## **FINAL ENVIRONMENTAL IMPACT REPORT**

**EIR No. 96-0090-SUB(ZV)(CUB)(DA)**  
**STATE CLEARINGHOUSE No. 96051050**

**Vesting Tentative Tract No. 52172**

### **HARBOR GATEWAY CENTER**

**Figure 6  
Concept Plan**

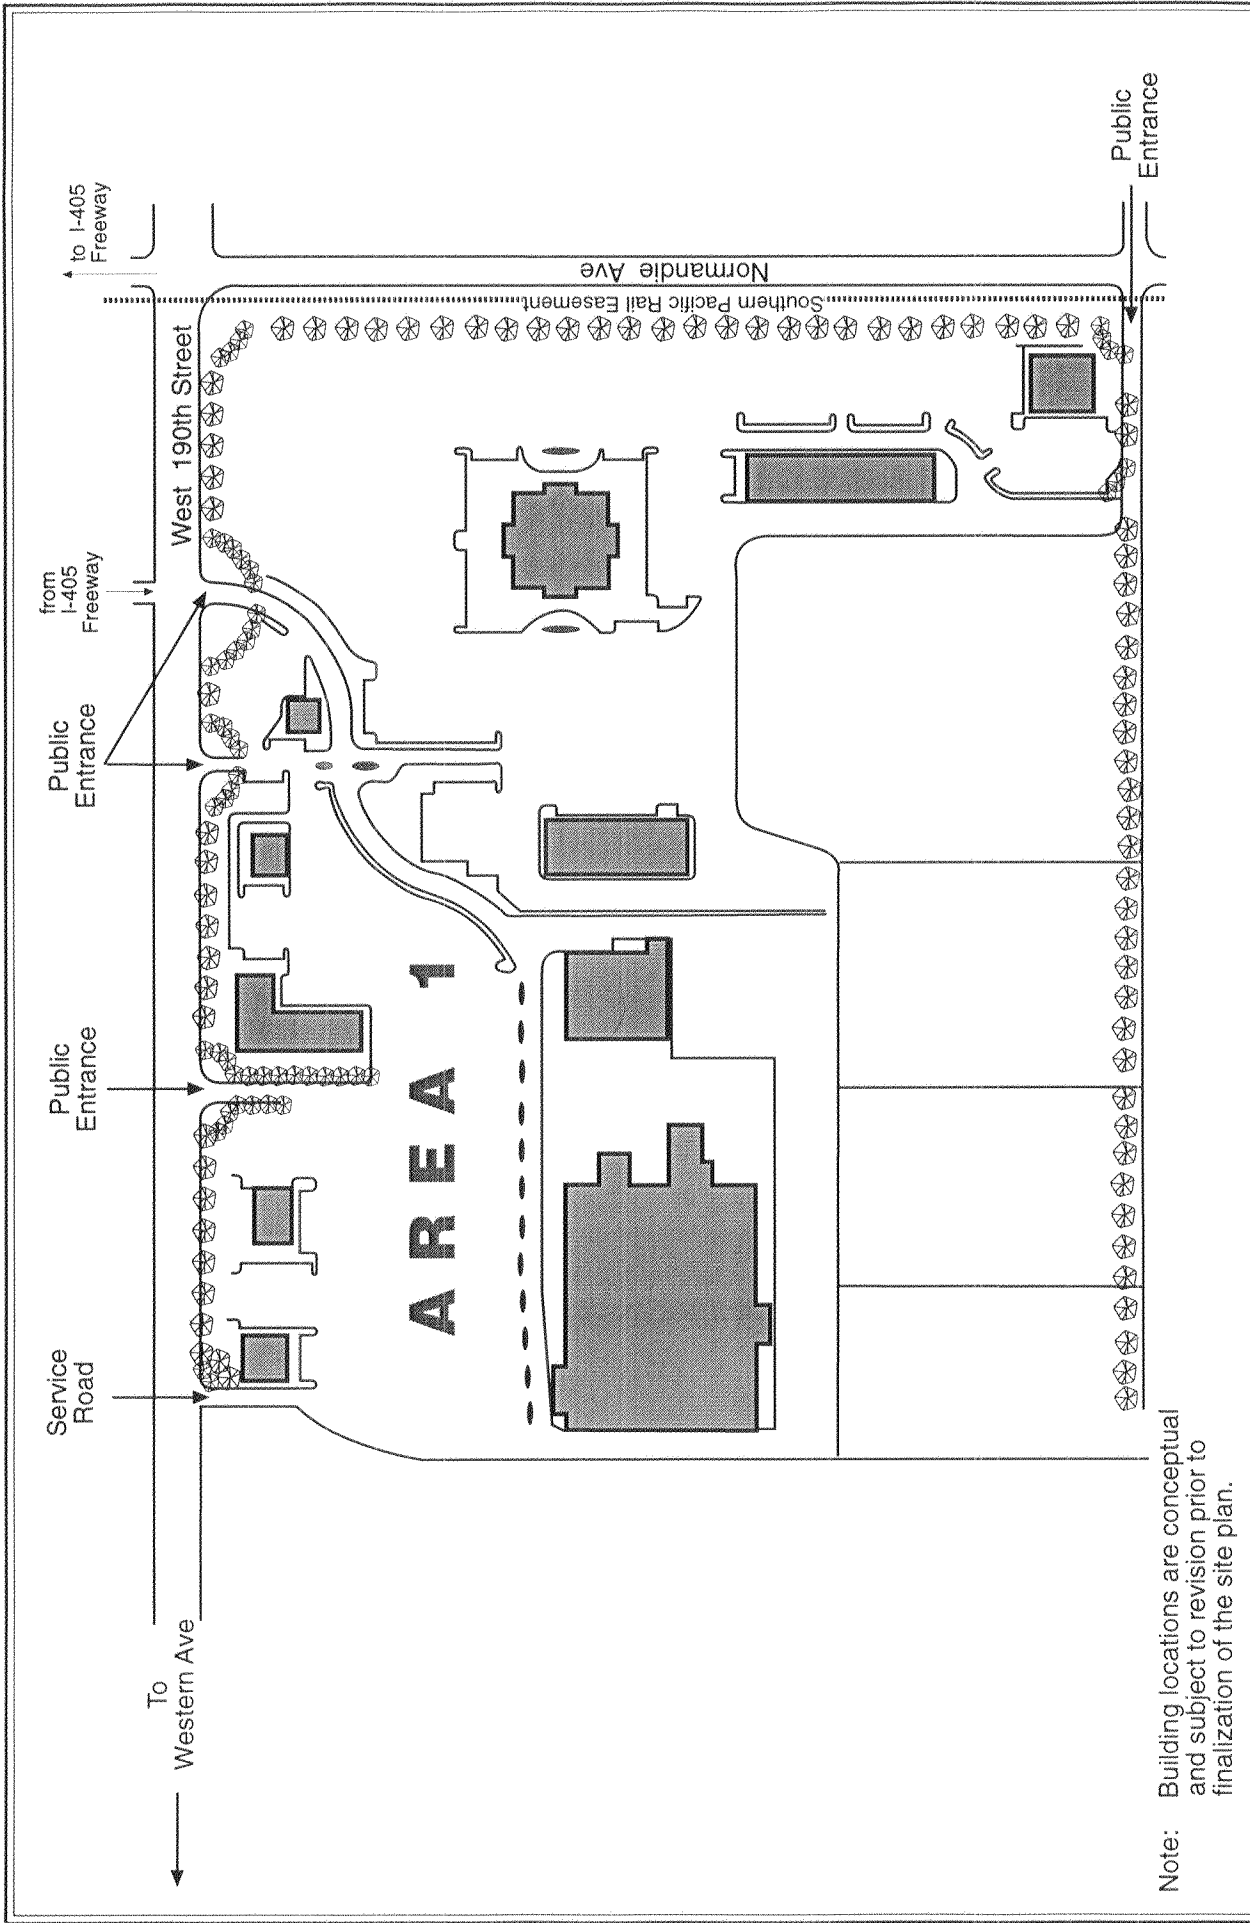
- j. D. Project Characteristics, page 65, revise Figure 6 as shown on page 55.
- k. D. Project Characteristics, page 66, Table 2, change footnote a to read:

**Figure 7  
Conceptual Area 1-  
Site Plan**

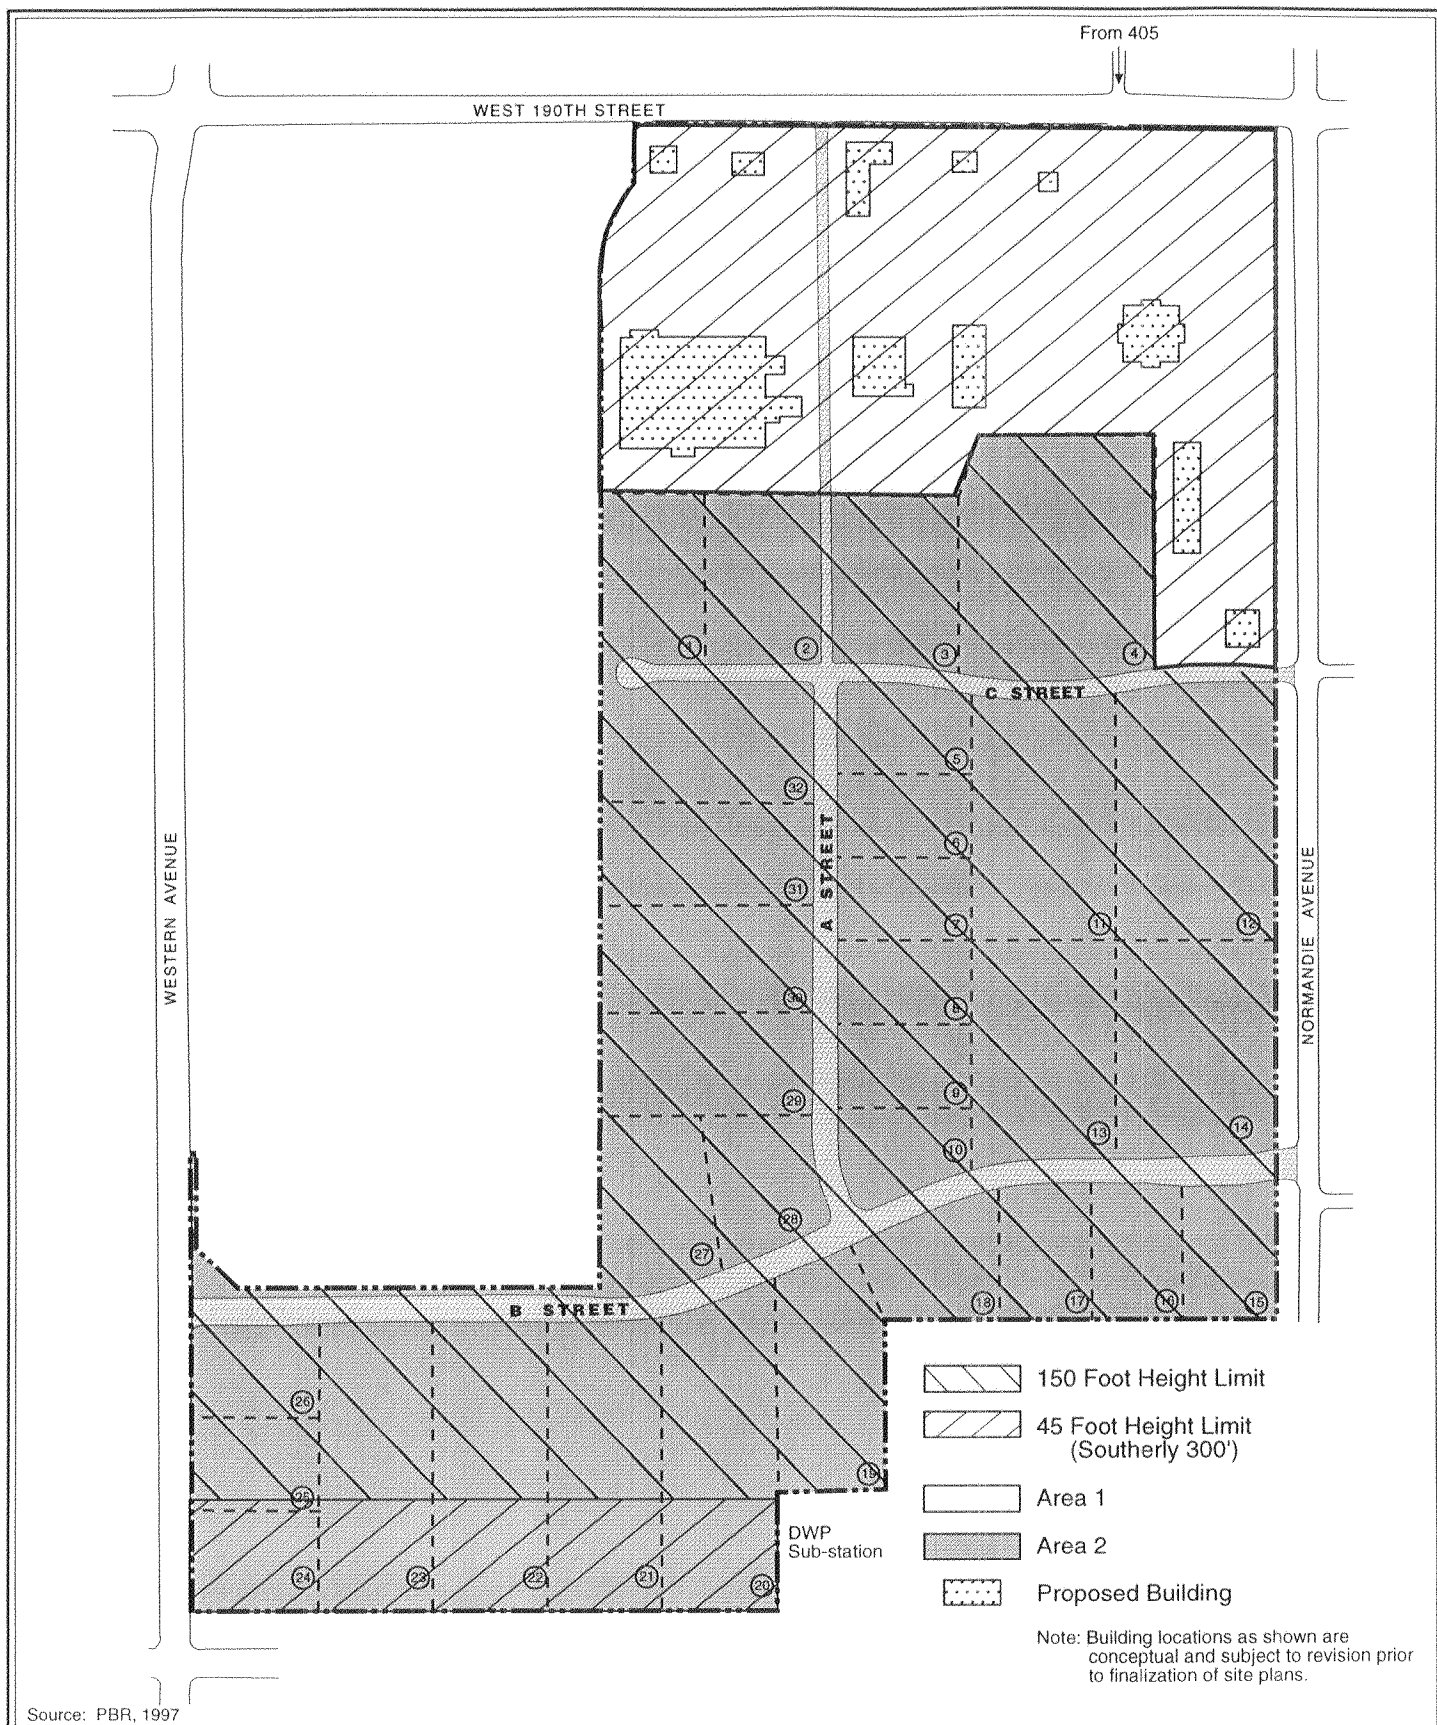
"Represents an approximately 0.25:1 FAR."
- l. D. Project Characteristics, page 66, first paragraph, fourth sentence, change "0.26:1" to "0.25:1".
- m. D. Project Characteristics, page 67, revise Figure 7 as shown on page 56.
- n. D. Project Characteristics, page 69, revise Figure 8 as shown on page 57.
- o. D. Project Characteristics, page 71, change the second paragraph under a. **Vehicular Circulation**, to read:

**Figure 10**  
**Internal Circulation System**

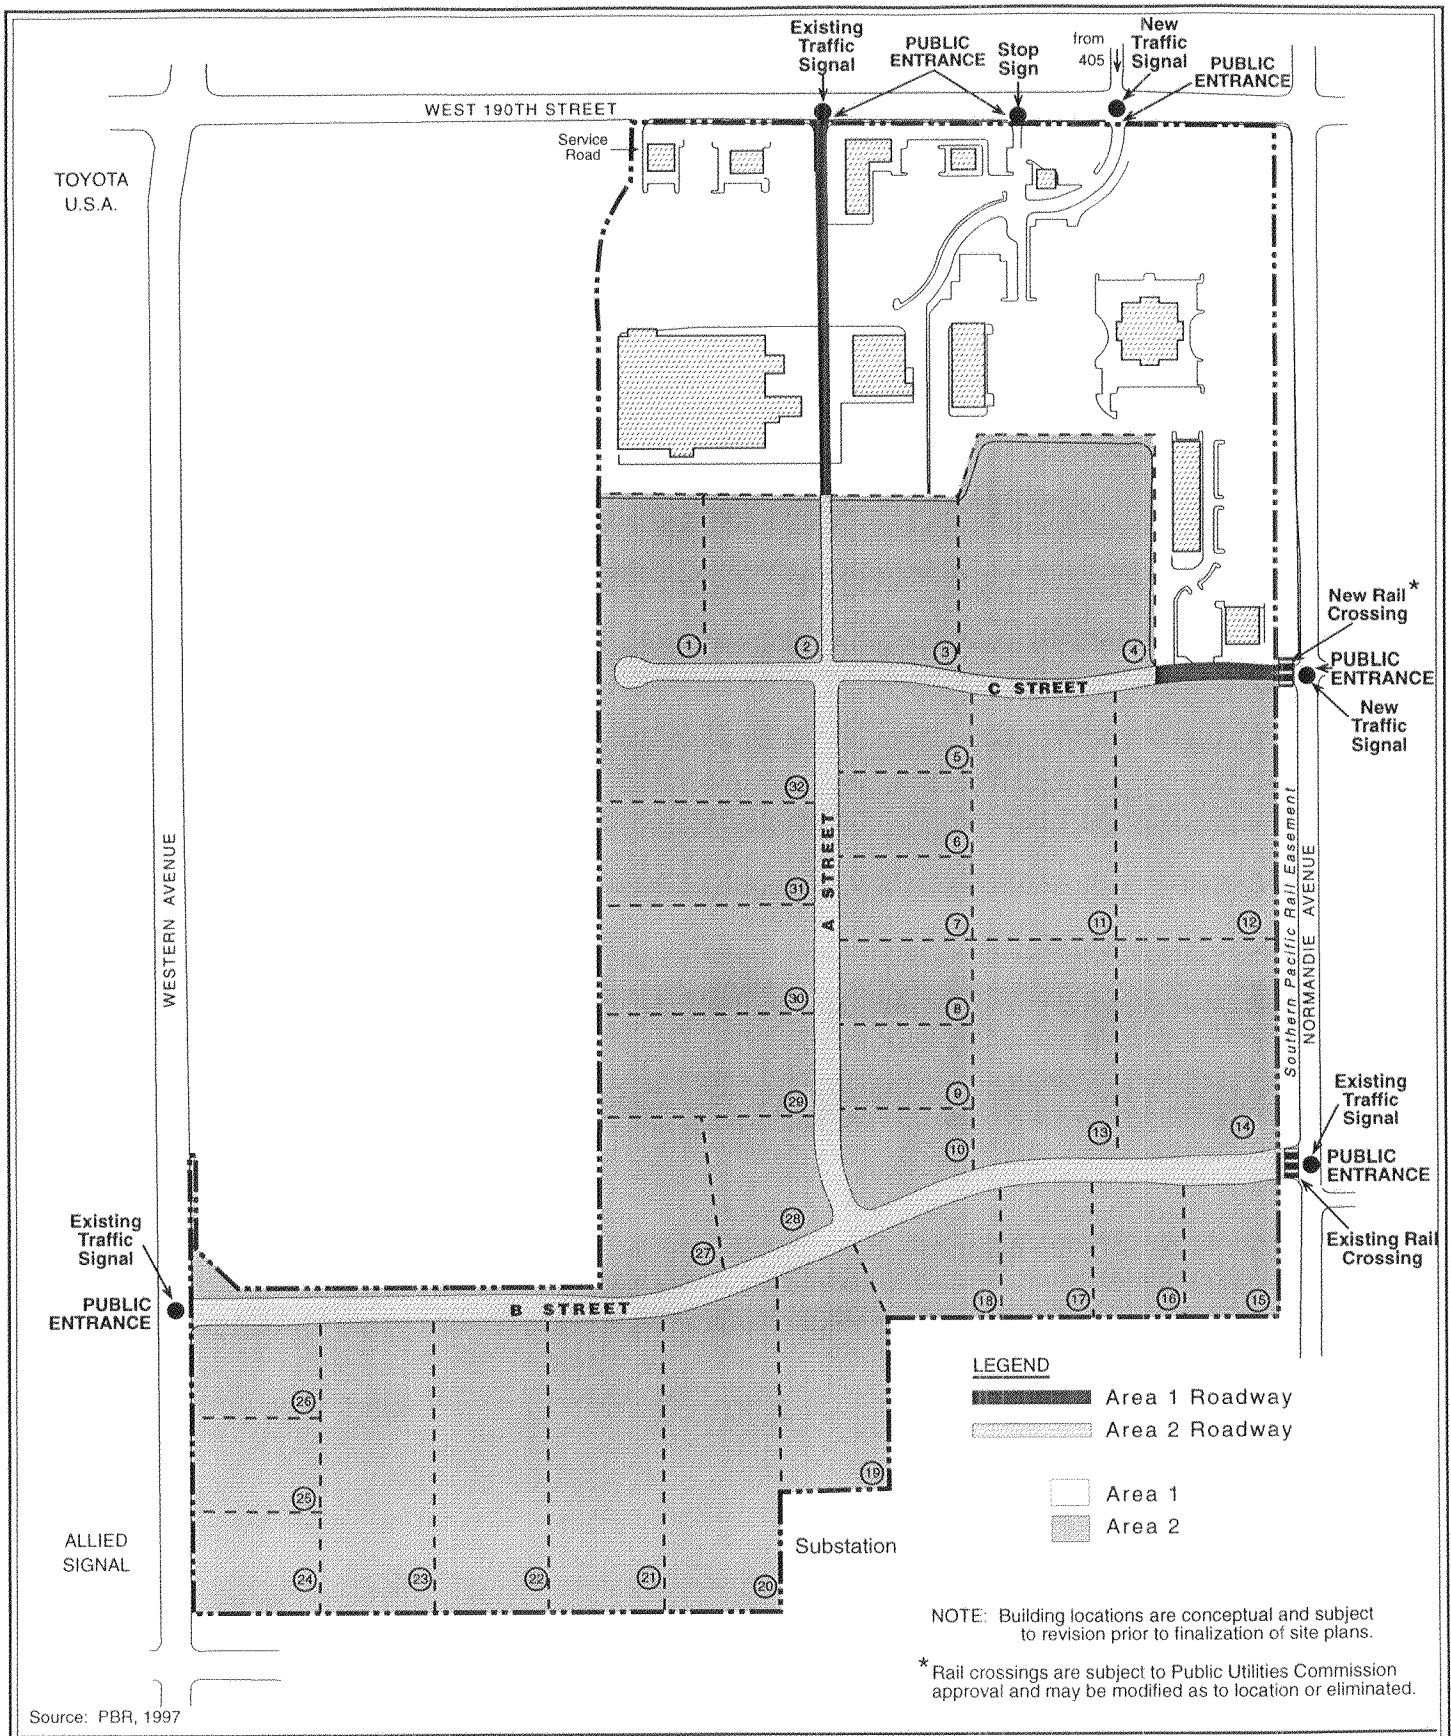
- s. D. Project Characteristics, page 72, revised Figure 10 as shown on page 59.

development (see Figure 10 on page 72). This roadway would also be maintained to provide access to Area 2, unless and until the extension of 195th Street between Normandie and Western Avenues (i.e., through the project site and the adjacent International Light Metals site) is undertaken. If the extension of 195th Street is completed, which would require the cooperation of the adjacent property owner, the ingress-egress roadway would be modified so as to no longer provide access to Area 2, with alternate access to Area 2 being provided by the 195th Street extension. The ingress-egress roadway would continue to provide access to the Area 1 retail development. This roadway would be served by the existing traffic signal located at 190th and Denker Streets."

"As noted above, the proposed ingress-egress roadway would provide access to Area 2, up to its intersection with proposed "C" Street, an east-west street which would provide access to Area 2 from Normandie Avenue via a new rail crossing, as discussed below."

"South of "C" Street, a new "A" Street would be constructed to serve proposed industrial park/office lots. "A" Street would extend south to intersect with "B" Street."

"C" Street would extend westward from Normandie Avenue to a cul-de-sac at the western edge of the project site."
